# Tacoma LNG Fire and Safety Review

**Report Number : BEP1251-05**  
**Revision : 5**

**Prepared for:**  
**The City of Tacoma Fire Department**

**Figure 12 - Tacoma LNG Thermal Radiation Cases (Drawing 000-SE-01-000011, Revision D)**

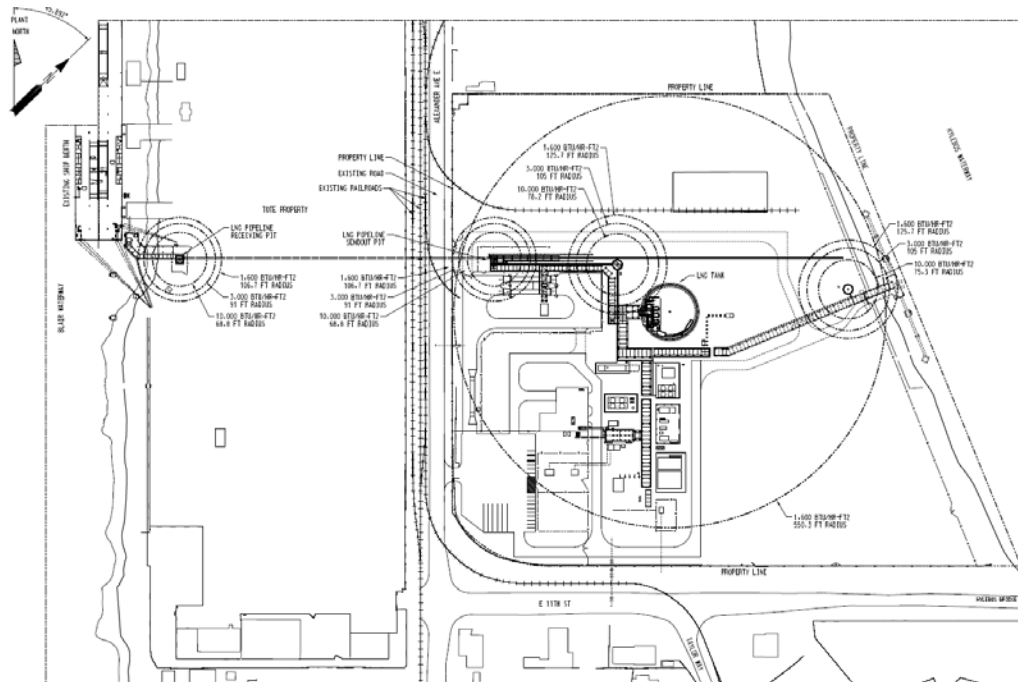
A code approved methodology for calculating thermal radiation siting was used to demonstrate the 1,600 BTU/ft<sup>2</sup>-hr thermal isopleths remain within the LNG plant boundaries. Tacoma LNG was found to be code compliant with thermal radiation requirements, except one (1) case, identified at the Blair Waterway dock where thermal isopleths extend beyond the LNG facility fence boundary line (Figure 13). TOTE and Tacoma LNG prepared and approved a Pipeline and Control Measures Easement Agreement dated 8/2/2016 to mitigate the Blair Waterway dock area for thermal radiation.

**Figure 14 - Pipeline and Control Measures Easement Area**

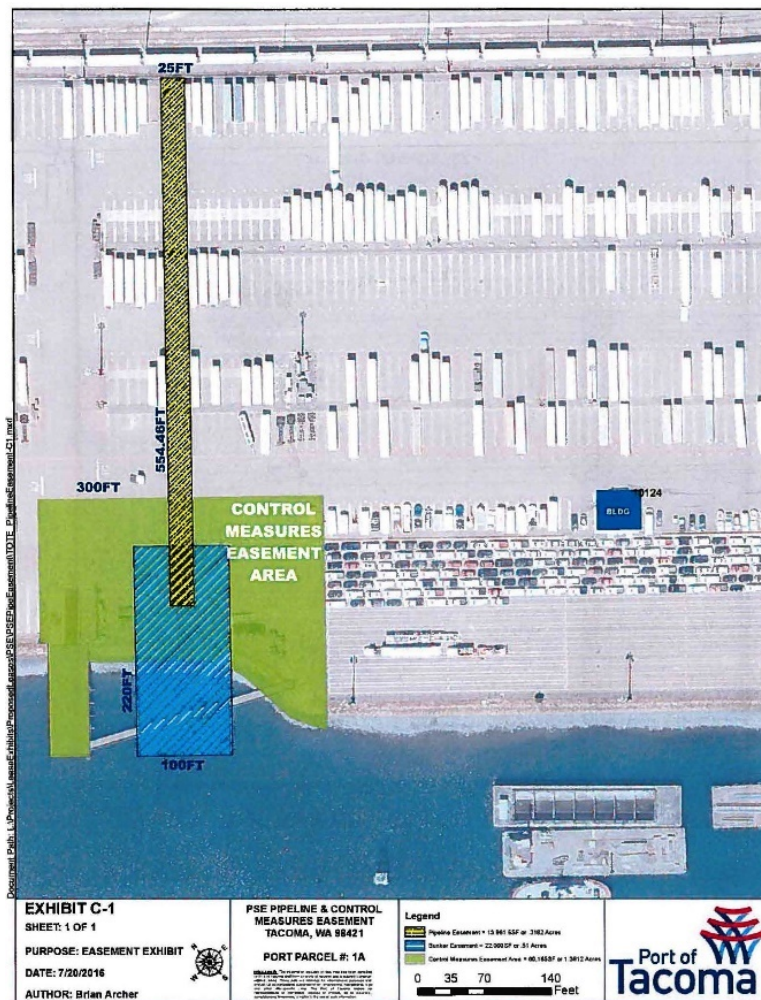
In this easement agreement, TOTE legally accepts certain use limitations on their property within a defined 1.3812 acre "Control Measures Easement Area" (Figure 14), in green, that includes the effects of thermal radiation and achieves code compliance at this location for thermal radiation.

A fire incident at this location has greater consequences due to the dock area uses, and potential impacts to dock workers unaffiliated with the LNG facility operation. For an LNG incident scenario where LNG and vapor is released at or near the dock, and is ignited, depending on severity and location, thermal radiation may extend beyond the security fence to the adjacent TOTE property. Because this is an open area, and not a confined space, properties of LNG/natural gas will not cause a detonation (explosion) of the vapor. An ignited gas fire will burn as long as fuel is present.

**Figure 15 - Vapor Dispersion Blair Dock - PHAST Model**

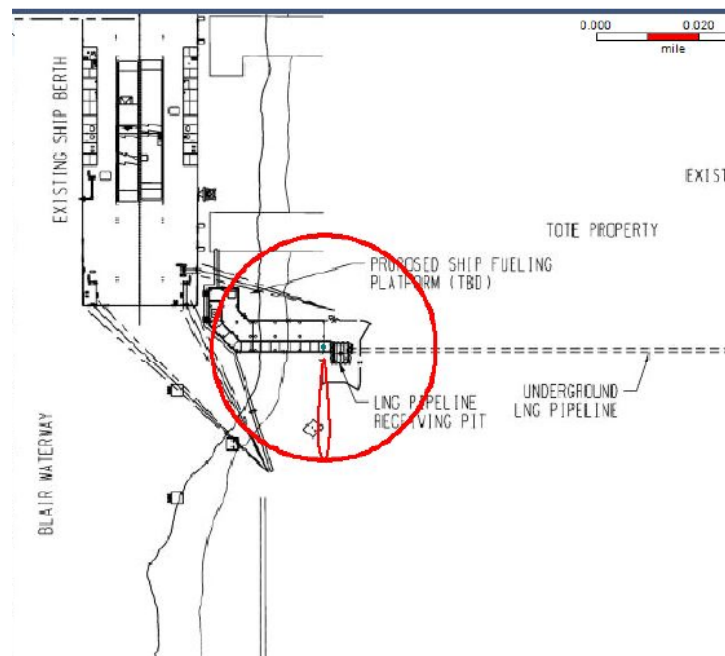
The CB&I report Appendix E – PHAST Analysis Results: Vapor Dispersion Plots, is a consolidated report containing fourteen (14) code-prescribed vapor dispersion design worst-case spill cases for the facility and evaluated for compliance. A code approved methodology for calculating vapor dispersion siting was used to demonstrate the 50% LFL isopleths remain within the LNG plant boundaries. Tacoma LNG was found to be code compliant and meets the vapor dispersion requirements, except one (1) case, identified at the Blair Waterway dock where vapor dispersion extend beyond the LNG facility fence boundary line. PHAST was used first by CB&I to evaluate vapor dispersion cases and summarized in Appendix K DOCUMENT NO.: 186512-000-SE-RP-00001, Revision C, 6/9/15 (Figure 15). The PHAST model is acceptable to PHMSA for demonstrating compliance to siting, and known to provide conservative results. The software illustrates the vapor dispersion limits as a circle, and is not sophisticated enough to account for 3-D graphical variations with the same detail as the Gexcon's CFD FLACS model. The PHAST model is also unable to include the 10-foot-high vapor barrier. The vapor limits are shown beyond the LNG security fence to the TOTE work areas.

The Pipeline and Control Measures Easement Agreement dated 8/2/2016 mitigates the issue at the Blair Waterway dock area. It includes consideration of vapor dispersion beyond the LNG facility boundary fence for a worst-case design spill scenario. To reduce migration of flammable vapor toward the TOTE ship loading ramp, a 10-foot-high vapor barrier was added to the original design of the Blair Waterway dock. Vapor dispersion modeling was updated to include the effects of the added vapor barrier and more sophisticated software was used to analyze. A Supplemental Letter from Gexcon to CB&I dated 9/17/15 includes a number of updated vapor dispersion figures using their 3-dimensional computational fluid dynamics (CFD) vapor model “FLACS”. The prevailing case from the Gexcon letter is shown with 1 m/s wind (Figure 16), where red indicates an impermeable barrier and green a 10% porous barrier. The vapor dispersion is less than before, but is still shown going beyond the LNG security fence to the adjacent TOTE dock work areas, including the loading ramp. The original Gexcon vapor dispersion modeling report dated 6/23/15

Figure 18 - VCE Area 1 Liquefaction Area

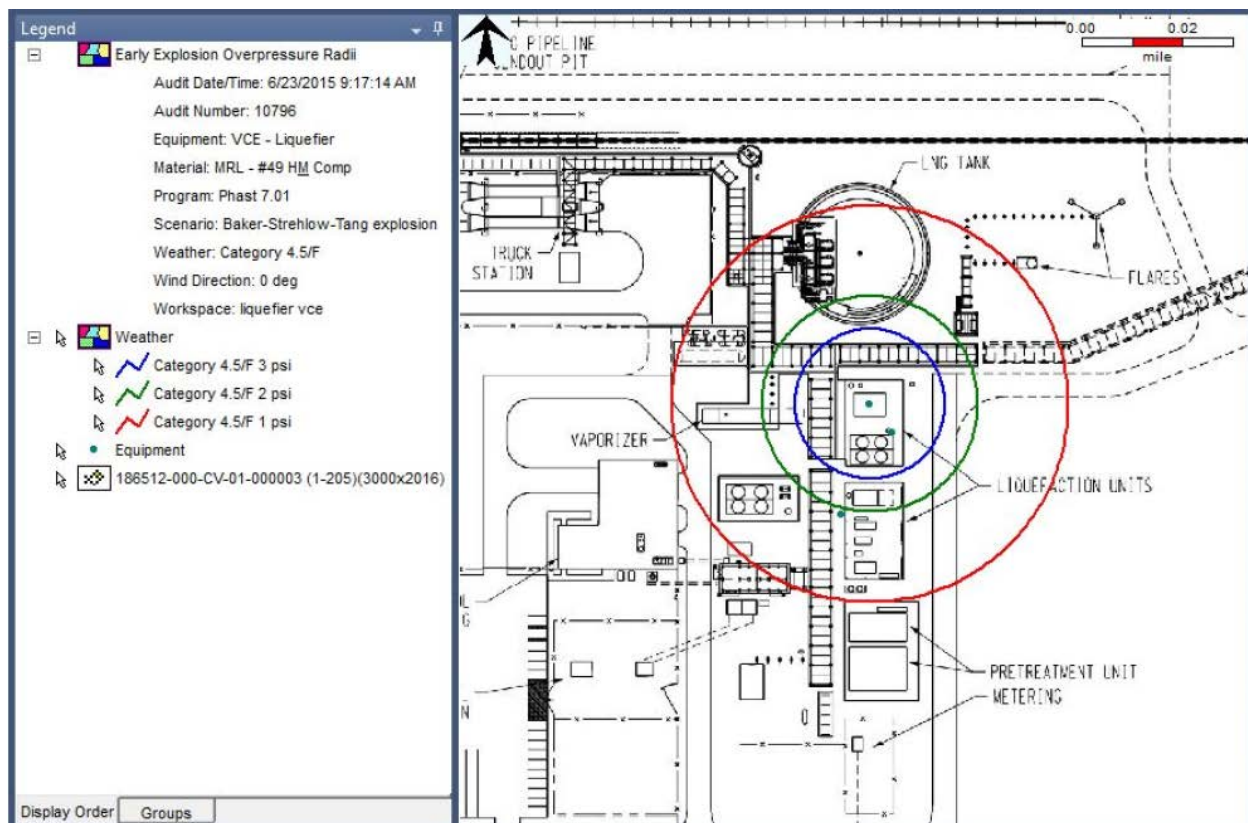
Gexcon performed VCE modeling and generated a VCE analysis report for Tacoma LNG, Appendix L, Document No.186512-000-SE-RP-00001 REVISION: C, dated June 9, 2015. A single design spill scenario of Mixed Refrigerant Liquid (MRL) was used for modeling a VCE event. The plot plan was assessed for areas of congestion and confinement within the flammable vapor cloud of the credible MRL release scenarios, with a focus on scenarios in proximity to the control building (MRL Condenser Vessel V-204 failure). Two (2) areas were identified and modeled that may have the potential to hold up flammable vapor, show in Figure 18 and Figure 19:

Factors for congestion and confinement were identified based on qualitative assessment of the current facility layout and were assigned to each area. Results show that the 1.0 psi blast overpressure isopleth remains within the property line that can be built upon and does not encroach on occupied buildings in the facility (the control room). The LNG tank is protected from the VCE by its highly reinforced two-foot-thick concrete outer wall. The TOTE dock is outside the areas affected by VCE. Therefore, Tacoma LNG meets the criteria for VCE, and no additional measures are recommended.

Figure 24 - Tacoma LNG Firewater System

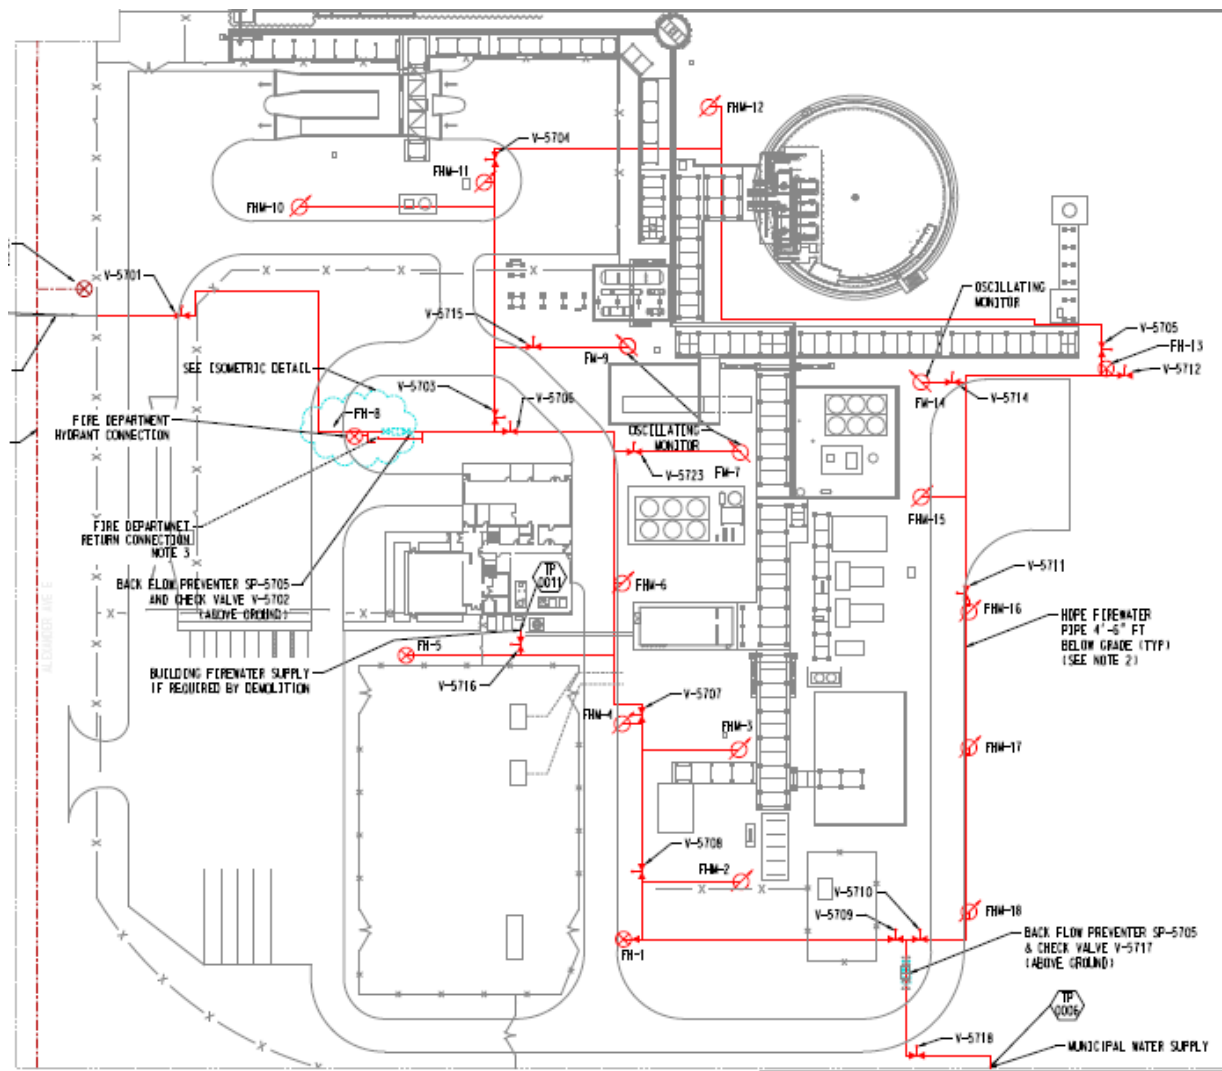
The Tacoma LNG facility design has adequate equipment for the detection and control of fires. For the LNG process areas, LNG storage, LNG truck loading, and LNG ship loading area, adequate firewater is available to provide radiant heat protection and cooling for adjacent piping, equipment, structures, and buildings during a potential fire event.

The firewater system consists of public utility water supply, firewater piping, hydrants and monitors, and building sprinkler systems with adequate capacity and reliability. The LNG facility is served by buried HDPE firewater distribution looped main in the LNG facility from the Tacoma Water supply point. The main plant firewater layout is shown in Figure 24. The firewater distribution loop pressure is maintained to about 100 psig.

Figure 28 - Hazard Detection System Layout - Main Plant Area

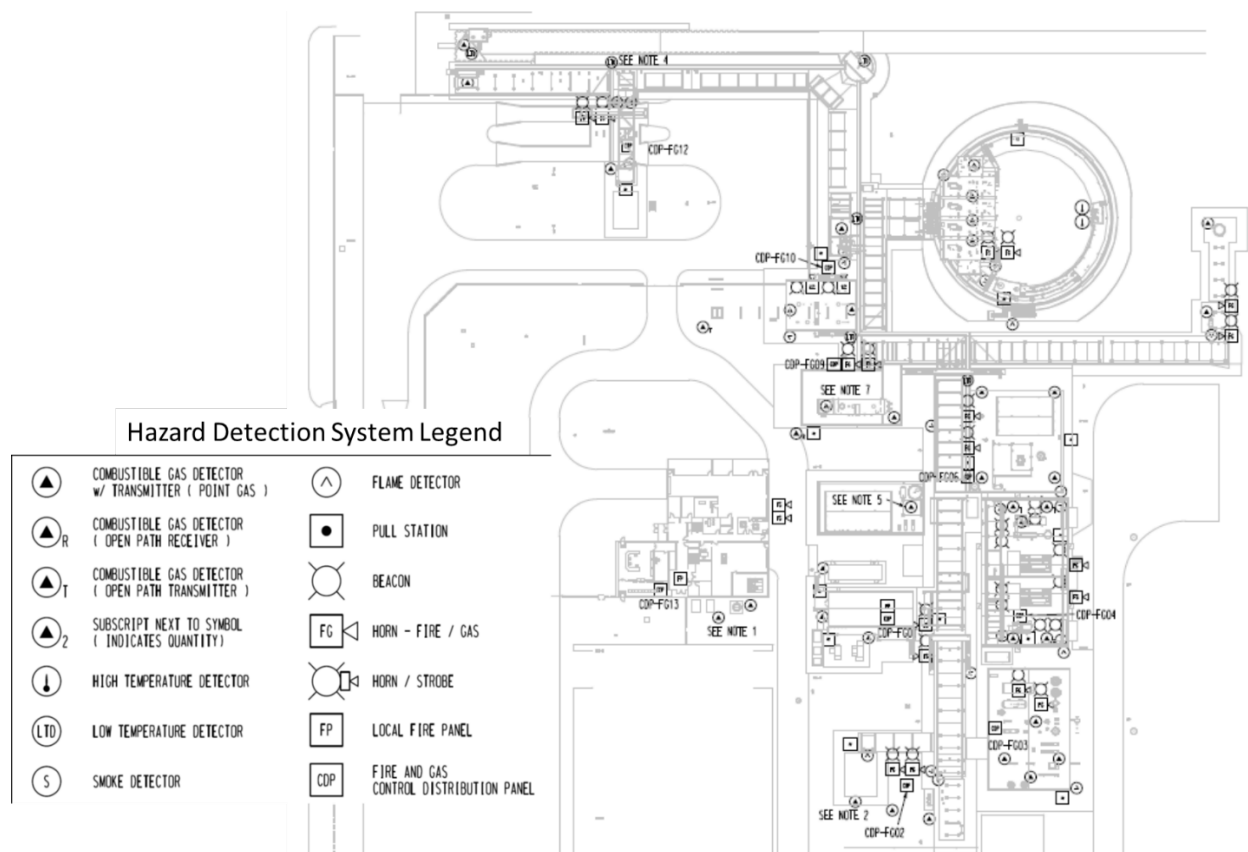
The Tacoma LNG design includes a wide-ranging hazard detection system; with fire, gas, and spill detection as required by NFPA 59A. The type, quantity, and location of equipment necessary for the detection of fires, leaks, and spills of LNG, flammable refrigerants, or flammable gases are adequate and appropriate and shown in Figure 28 and Figure 29.
